B	FOR FABRICATION			kenn	6-2-99
00	PRE-RELEASE	-	-	CHAPUT	4-6-98
REV	DESCRIPTION	DCN NUMBER	APPR'D	CHECK	DRWN DATE

LIGO CALIFORNIA INSTITUTE OF TECHNOLOGY MASSACHUSETTS INSTITUTE OF TECHNOLOGY			
TUBE, ETM MOUNT			
CAD FILE D980630-B	SIZE E	DRWG. NO. D980630-B	
SCALE 1 : 1		SHEET 1 OF 1

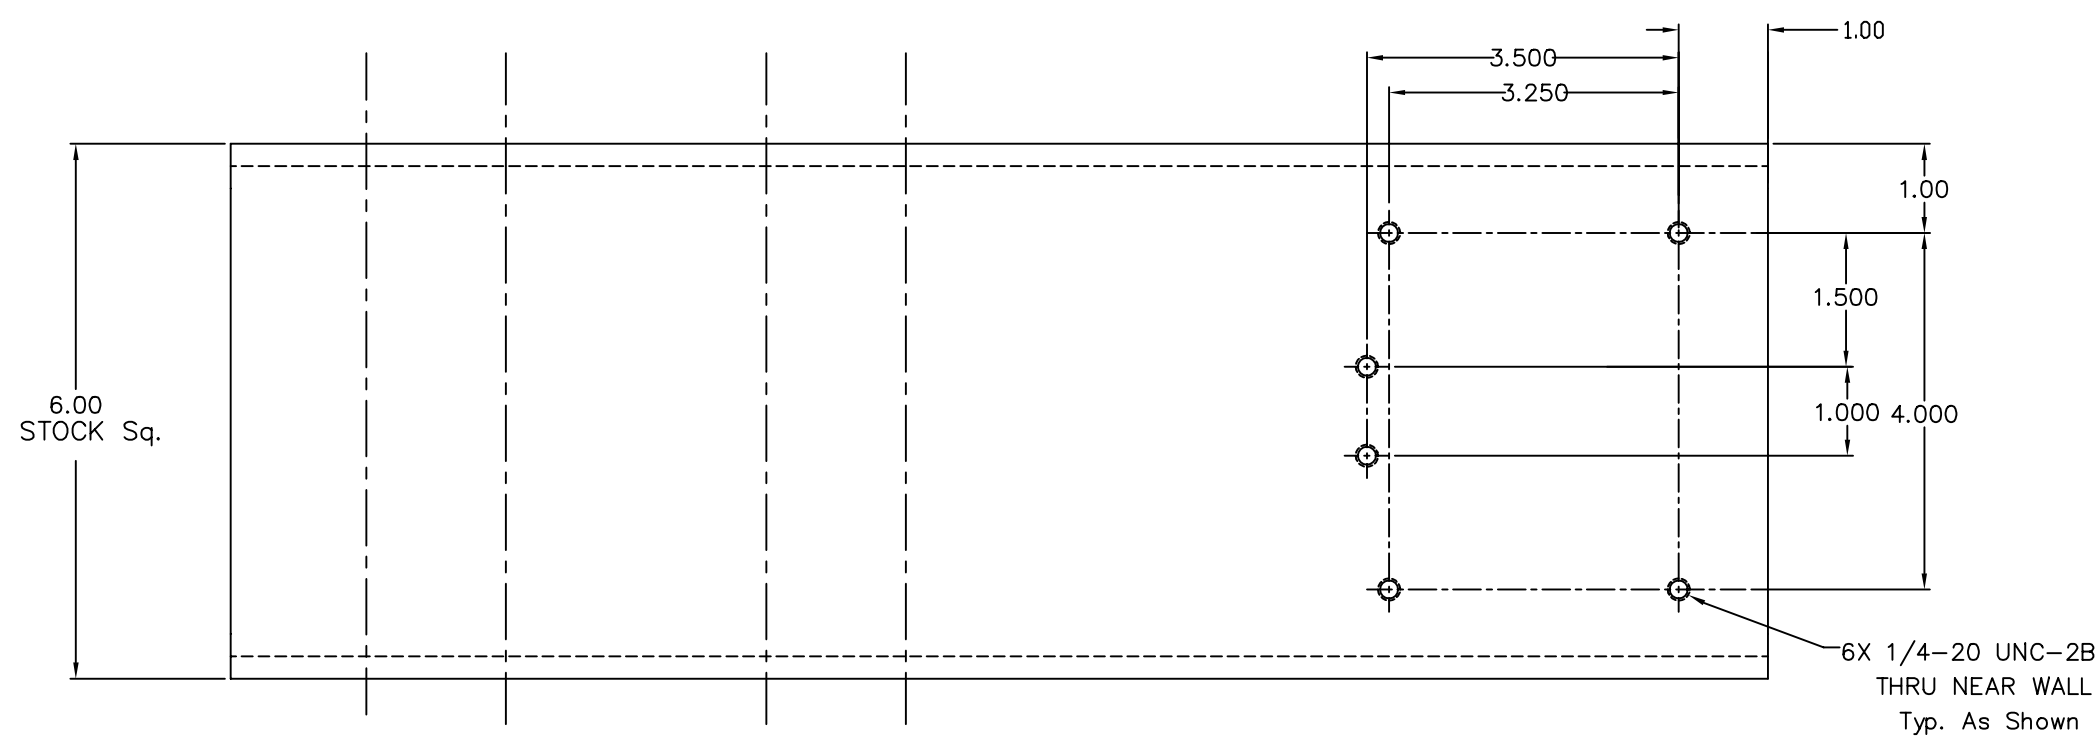
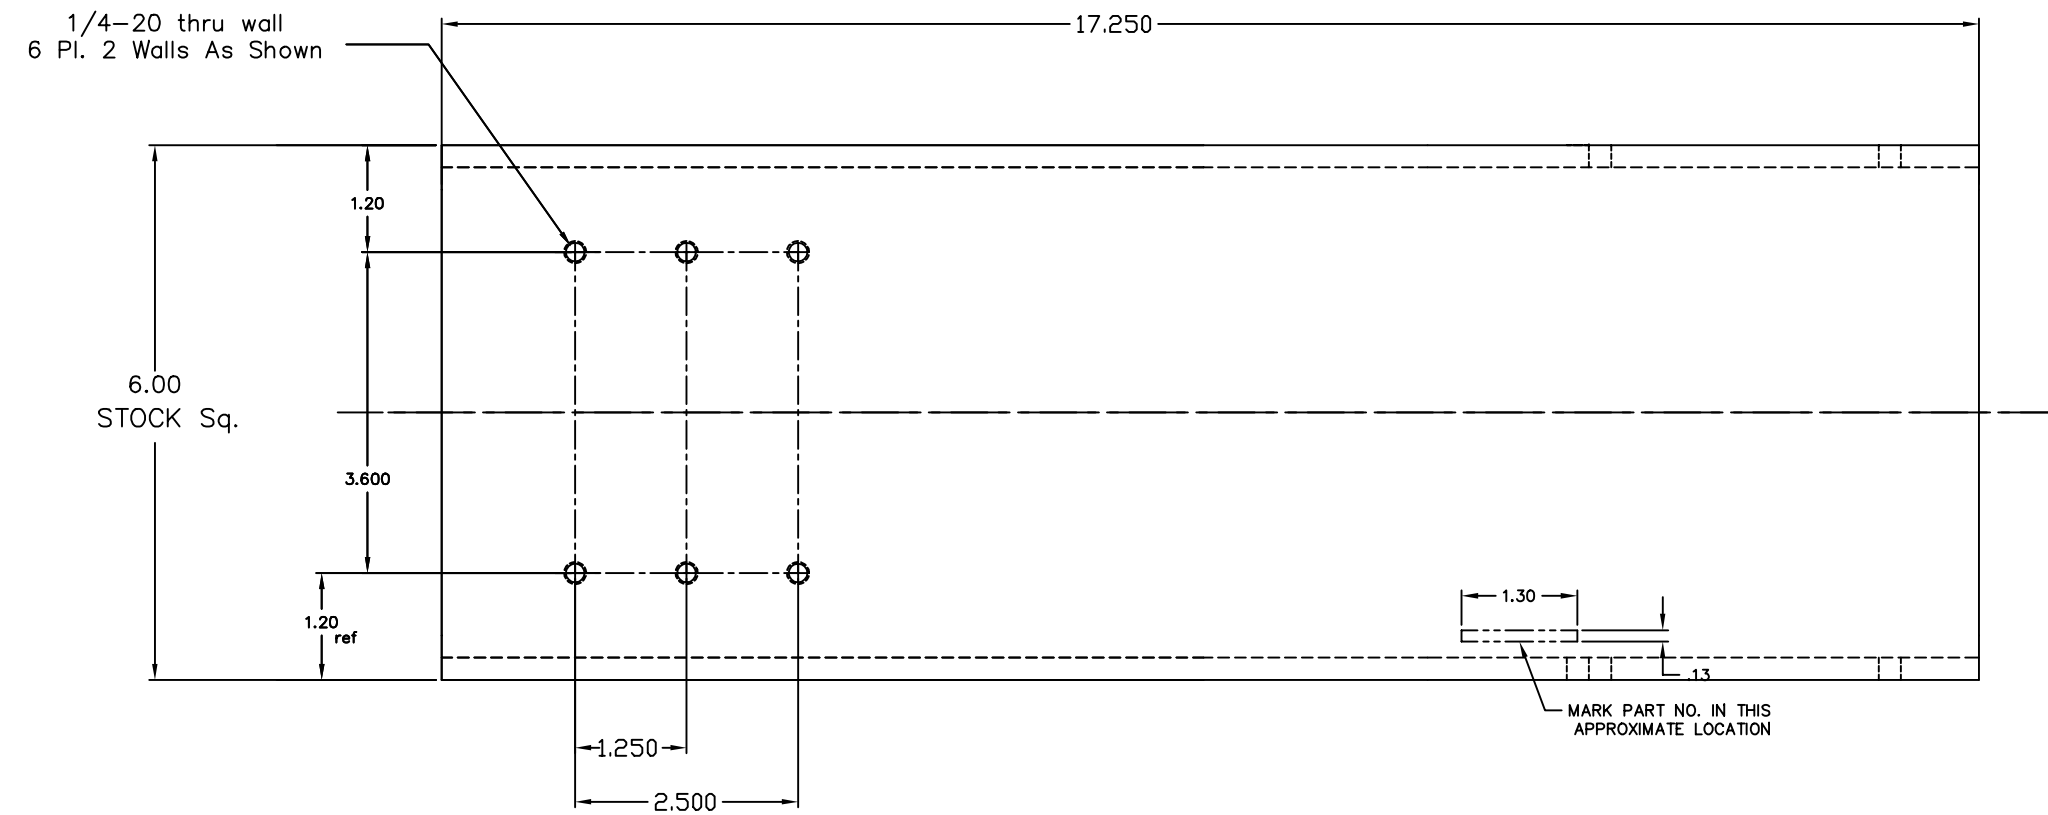
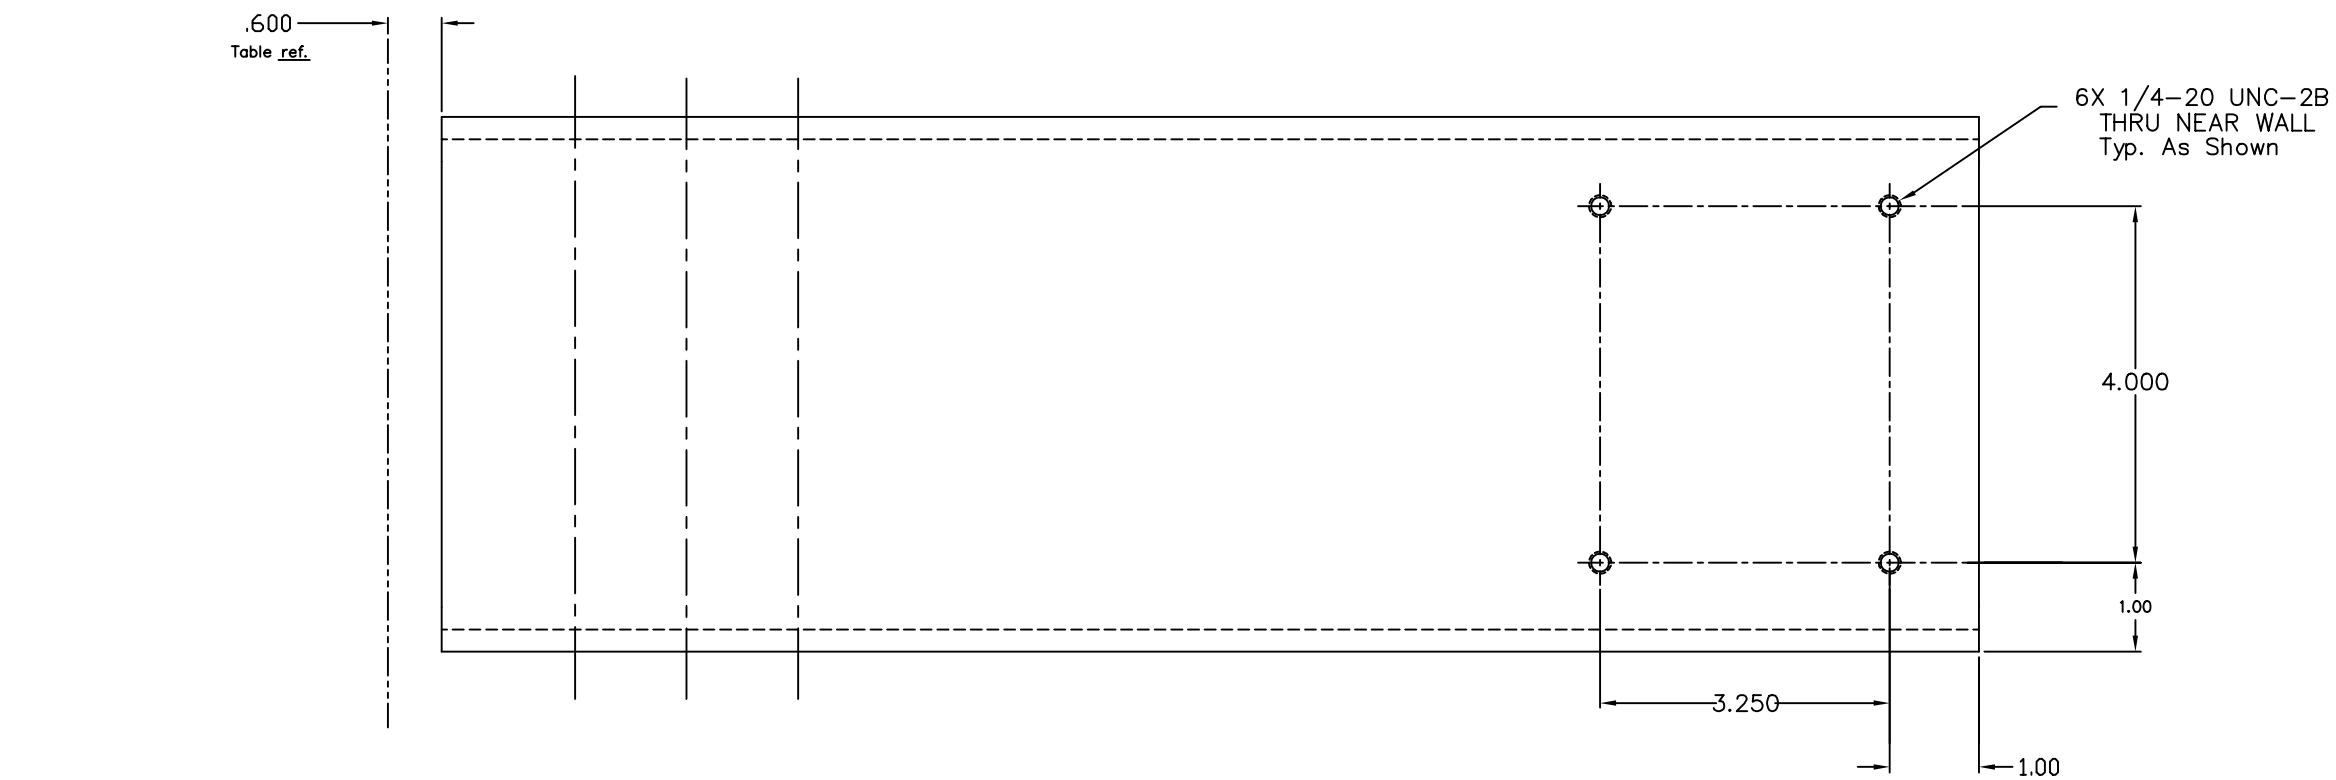
~~Liquid contaminants/Machining Lubricants~~  
 Liquids containing hydrocarbons or other contaminants, other than the machining fluids specified herein, shall not be allowed to come into contact with suspension material at any time. All machining fluids shall be water soluble and free of sulfur, chlorine and silicone; such as Cincinnati Milacron's Cimtek 410 (stainless steel).

~~Identification\_Serial Number~~  
 A serial number shall be etched, or scribed on the part see note drawing note.  
 Serial Number Format  
 The Serial number shall be of the format: D99xxx-x-001
